**SITE AND ARCHITECTURAL REVIEW COMMITTEE
TUESDAY, JUNE 28, 2016
6:30 p.m.**

Subject: The Cannery (Water Tower Plaza)

Application: Modification (PLN2016-73) to previously approved Planned Development Permits (PD84-02, PD84-05, PD90-01 and M92-11) to allow the exterior remodel of an existing building that is listed on the City's Historic Resource Inventory (George Hyde Co. Sunsweet Growers) as well as associated on-site and off-site improvements and a Tree Removal Permit (PLN2016-154) to allow the removal of protected tree(s)

Project Site: 300 & 307 Orchard City Drive

EXISTING GENERAL SITE PLAN
SCALE: 1" = 200'

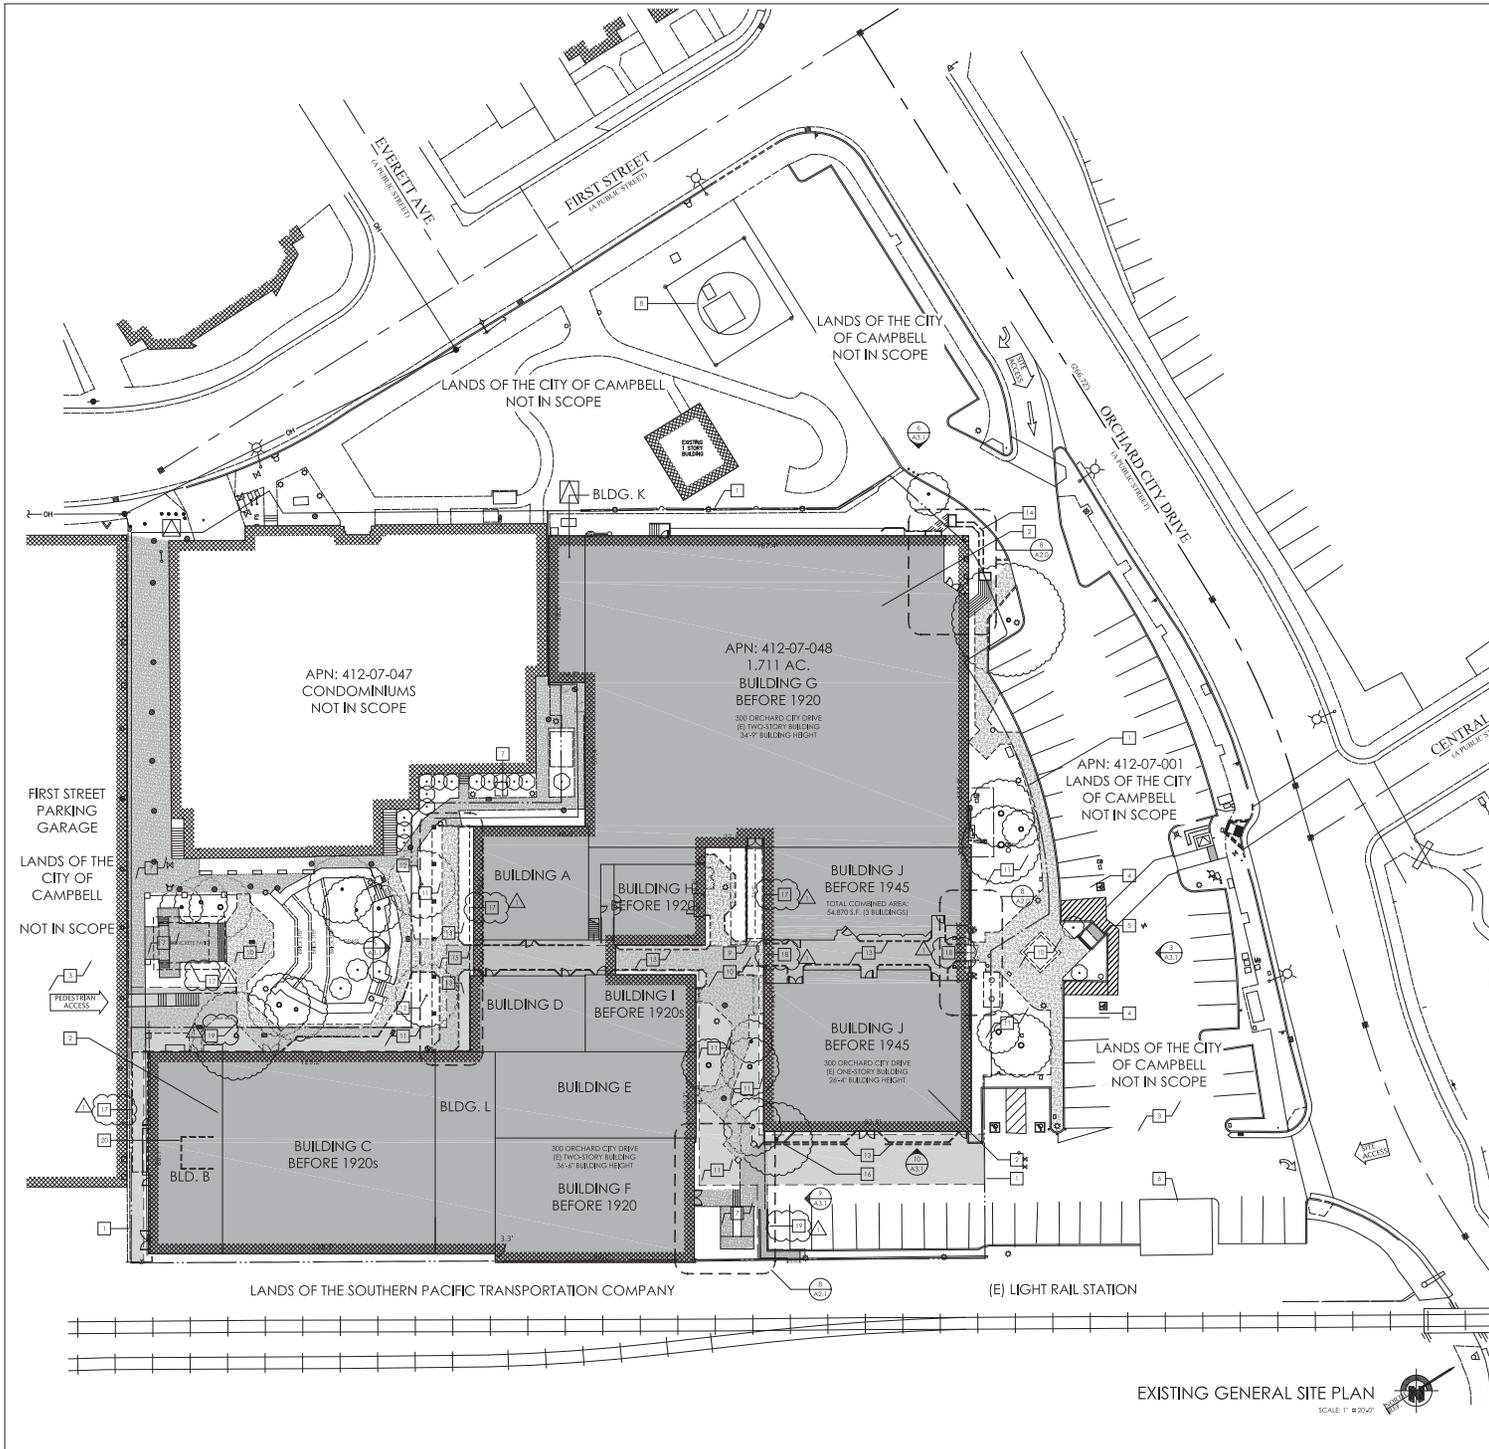
Tree Removal: As part of the proposed development, the applicant is requesting the removal of two olive trees which are located to the rear/southwest of Building A & D and one podocarpus⁵ tree located at the front/northeast of Building G (reference **Attachment 3** – Project Plans; Sheet A1.0). Pursuant to CMC 21.32 (Tree Protection Regulations) a minimum of three 24-inch box trees shall be required as replacements. In that the proposed schematic landscape plan (reference **Attachment 3** – Project Plans; Sheet A1.2) does not indicate replacement trees, a discussion point has been raised to determine if the SARC would have a preferred planting location.

Figure 3: Proposed Architectural Elevation Drawings

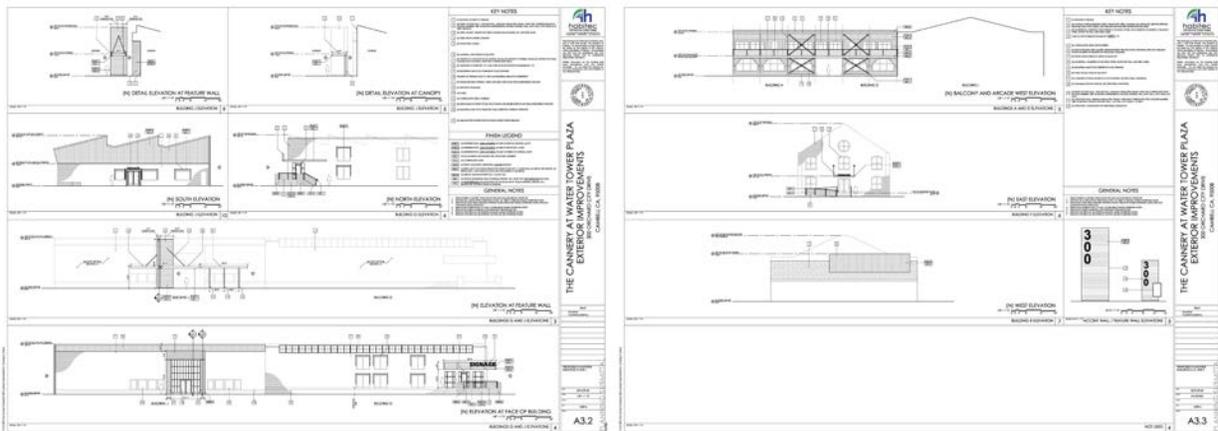
2. In addition, upon my visual examination of the front elevation of the building (viewed from the front parking lot connecting Orchard City Drive), it appears that there are several horizontal in-fill brick courses visible just below the upper applied stucco parapet wall. This upper section of the front wall had been the original location where the clerestory windows (Figure 5 and Figure 6) had been placed. Correlating these observations with the current proposed drawings (Figure 3), it is difficult to determine if the architect's intention is to remove only this in-fill brick section or to rebuild the entire parapet within this upper wall location. Since there have been no enlarged building sections of this area provided, it is unclear how this very important proposed design element is to attach to both the roof structure, or the existing brick wall of the façade; and as a consequence what amount of demolition and reconstruction is actually required.
